CARRIAGE OF CARGOES AND CONTAINERS

Clarification on the draft new paragraph 4.19.1.7 of the IGC Code pertaining to the duplication of the heating system

Submitted by Panama, Republic of Korea and IACS

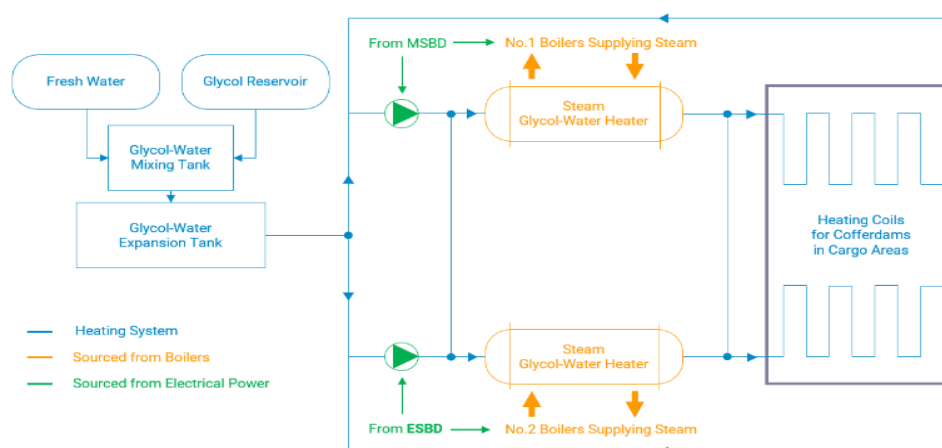
4 Among the extensive amendments to the IGC Code, the draft new paragraph 4.19.1.7 is intended to supplement and clarify the existing paragraph 4.19.1.6, which addresses duplication of heating systems protecting the hull structure from exposure to the low temperatures of liquefied gases. This new provision originates from document CCC 8/10/3 (IACS and SIGTTO) and reflects the unified interpretations of paragraph 4.19.1.6 set out in MSC.1/Circ.1606. The draft text of this new provision, which remains almost identical to the amendment proposal in document CCC 8/10/3, is contained in annex 15 to document MSC 110/WP.7.

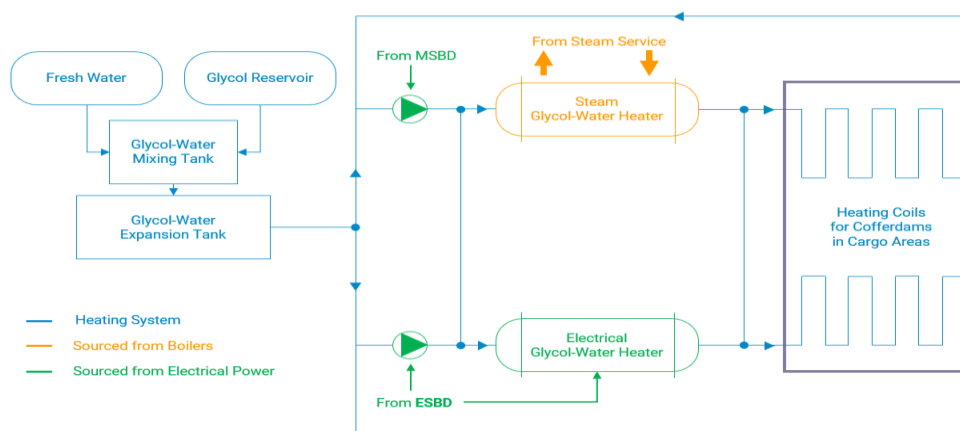
7 Specifically, interpretation 1.2 in MSC.1/Circ.1606 clarifies that, where the heating system is duplicated, all electrical components of at least one of the systems should be supplied from the emergency source of electrical power, in line with the existing paragraph 4.19.1.6.2. Interpretation 1.3 further specifies that, in cases where duplication of the primary heat source (e.g. an oil-fired boiler) is not feasible, other duplication arrangements, such as those associated with an alternative electric heater, may be accepted but should be supplied from the emergency source of electrical power. In practice, these requirements have been applied as elaborated in sub-paragraphs .1 and .2 below:

- .1 When the duplicated system consists of two steam heaters, each associated with its own glycol circulation pump and auxiliary boiler, only one set of electrical components, i.e. one glycol circulation pump, one auxiliary boiler, etc., is supplied from the emergency source of power, as illustrated below:
